ENGINEERING BULLETIN No. 18

**Recommended Repair and Alteration for
Fraying Rudder Cables**

Aircraft affected: All Luscombe Model 8 Series aircraft up to and including Serial No. 1894.

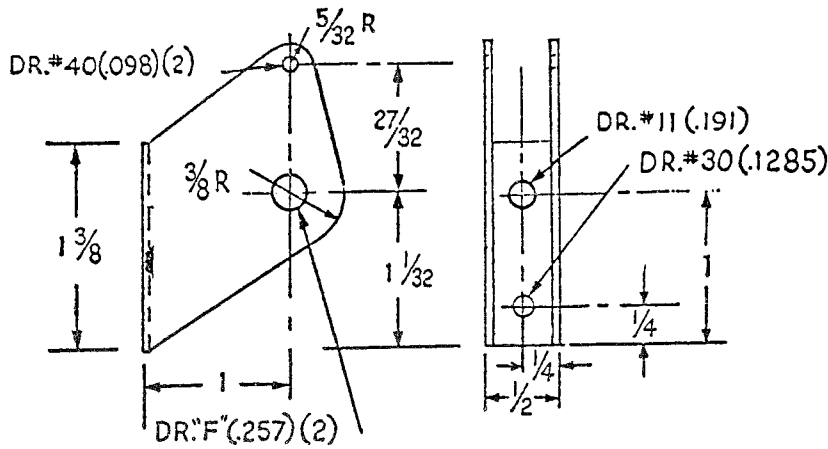
The fraying of rudder cables at bulkhead #7 has led to the substitution of pulleys (LAC Drawing #28099) for the former fairleads (LAC Drawing #18058), and to our recommendation that you make the same change on any and all subject aircraft in your possession as soon as possible.

The Civil Aeronautics Administration will require the above change to be made before the next annual certification of these aircraft. The required change is outlined and illustrated on page 70.

INSTALLATION DETAILS

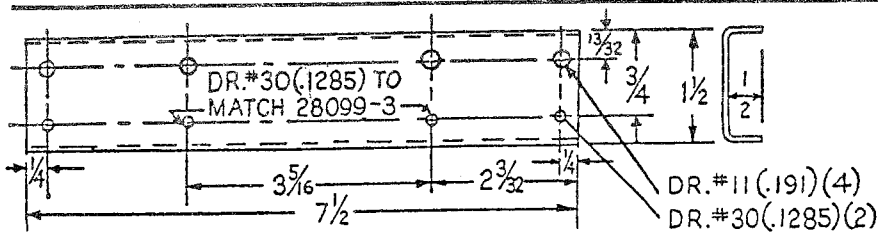
1. Replace the worn rudder cables with new ones. Luscombe Airplane Corporation parts #48501-2 and #48501-3.
2. Locate pulley bracket as per sketch, making sure the rudder cables do not rub against the skin slots, and drill bulkhead #7 to match.
3. Bolt bracket in place.
4. Safety cables over pulleys as per sketch, and adjust.
